BULLETIN NUMBER:  
**SB18-C-001D**

## **DOOR WIND NOISE/WATER INTRUSION – IMPROVED DOOR SEAL AND ADJUSTMENT PROCEDURE**

***This bulletin is being revised to provide VIN breakpoint information and updated vehicle applications. This bulletin supersedes bulletin SB18-C-001C. Please discard bulletin SB18-C-001C.***

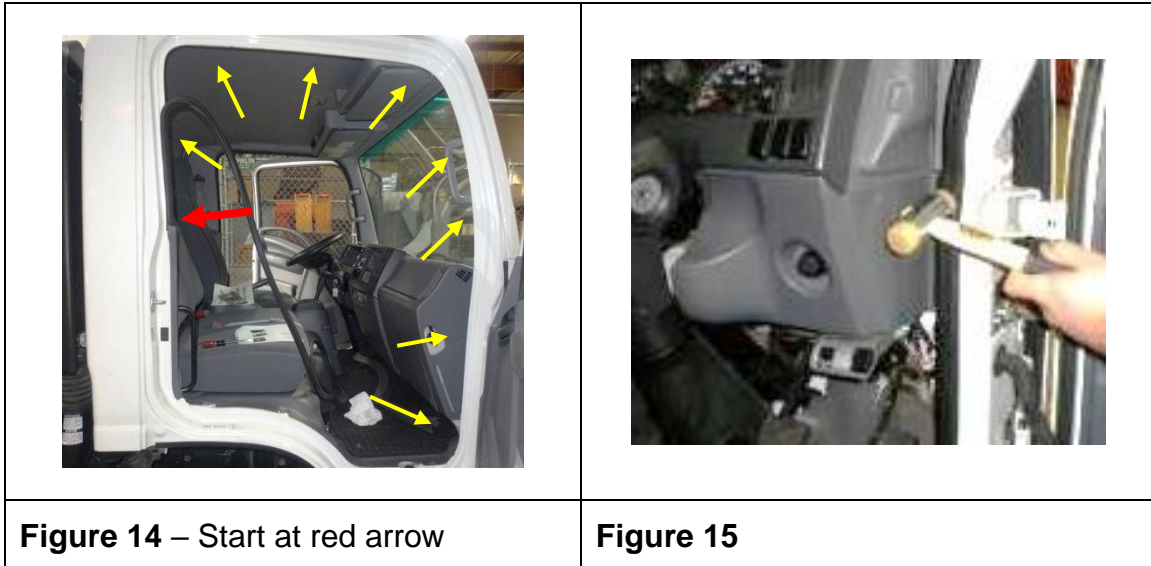
10. On single cab, N-Series vehicles check the seal on the **cab-side** of the door opening (See Figure 9) to determine if it is an original seal design or a previously offered revision. (See Figures 10 & 11.)
  - a. If the original seals are present as shown in Figure 10, replace them with the redesigned **cab seal** and continue to Step 11.
  - b. If the seals on the vehicle's **cab** are as those shown in Figure 11, skip to Step 24.
  - c. If vehicle is an FTR, continue to Step 11.

11. Remove the passenger door sill protector by removing four (4) screws. (See Figure 12.)
12. Remove the old weather strip by pulling weather strip away from the cabin pinch weld surface. (See Figure 13.)

13. Wipe down the pinch weld surface using a clean cloth. (See yellow arrows in Figure 14.)

14. Attach the new weather strip to the pinch welding surface, starting at the rear quarter side, marked by the red arrow in Figure 14, and work towards the front.

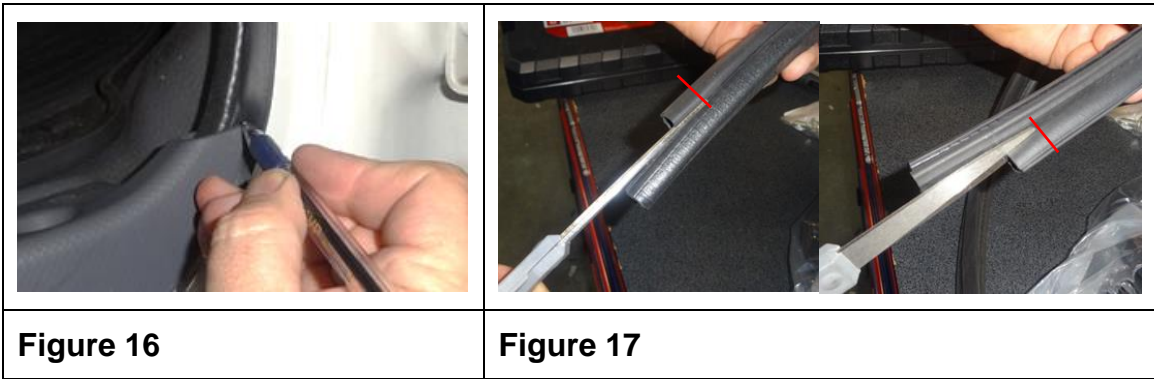
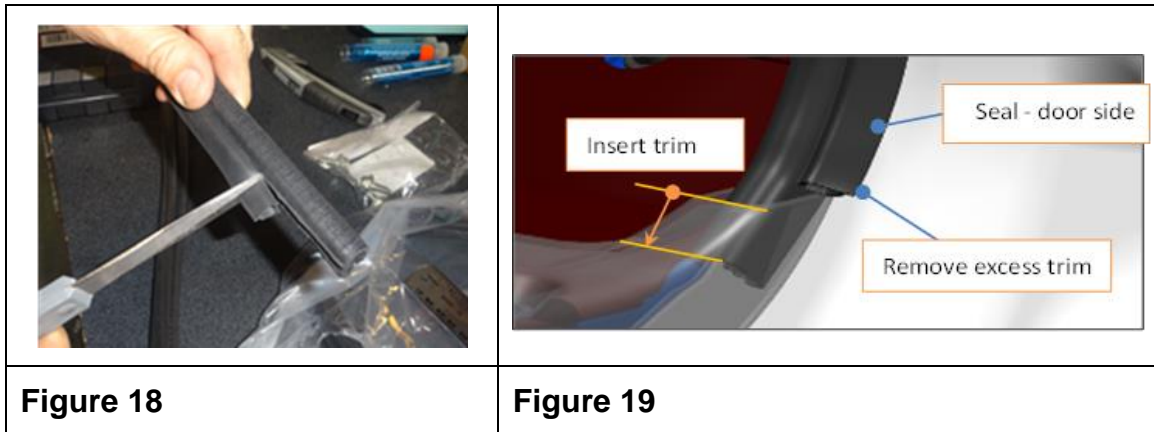
- If the new seal interferes with and sits below the door side sill protector, as shown in Figure 16 below, proceed to Step 17.
- If there is no interference, repeat on other side.
- If both doors have been completed, skip to Step 24.

17. Using a pen, mark the seal using the top of the door side sill protector as a guide to where the weather strip needs to be cut. (See Figure 16.)

19. Using sharp scissors, cut both sides of the weather strip at the attachment points up to where the pen mark is shown in Figure 17.

20. Cut off the piece of the seal that is interfering with the door sill protector. (See Figure 18.)

**NOTE: Weather strip should fit into the door sill protector without interference.** (See Figure 19.)

**Figure 20**

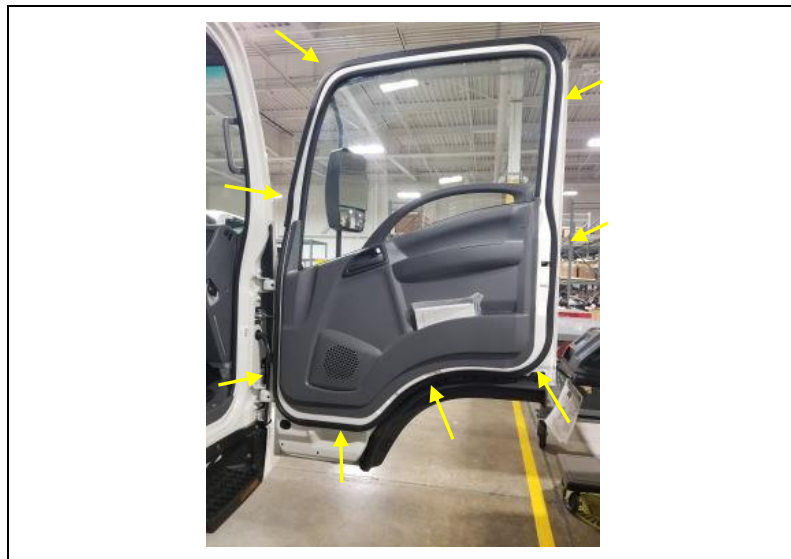
24. On single cab, N-Series vehicles check the seal on the **door side** of the door opening (See Figure 20) to determine if it is an original seal design or a previously offered revision.

- a. If the original seals are present as shown in Figure 20, continue to Step 25.
- b. If the seals on the vehicle's **door** are as those shown in Figures 21 & 22, skip to Step 29.
- c. If vehicle is an FTR, skip to Step 26.

25. Remove the side **door seal** shown in Figure 23 by pulling door seal from the door.
  - Using a trim panel tool or wire cutters remove mounting fasteners from door. (See Figure 24.)

- Start at the top, outside corner, as shown by red arrow in Figure 25.
- Fasten the seal, working across the top of the door and then down to the bottom of the door – see yellow arrows in Figure 25.
- Go back to the top corner and connect the seal down the opposing side of the door, working towards the bottom.
- Now fasten the seal across the bottom, as shown by yellow arrows in Figure 26.
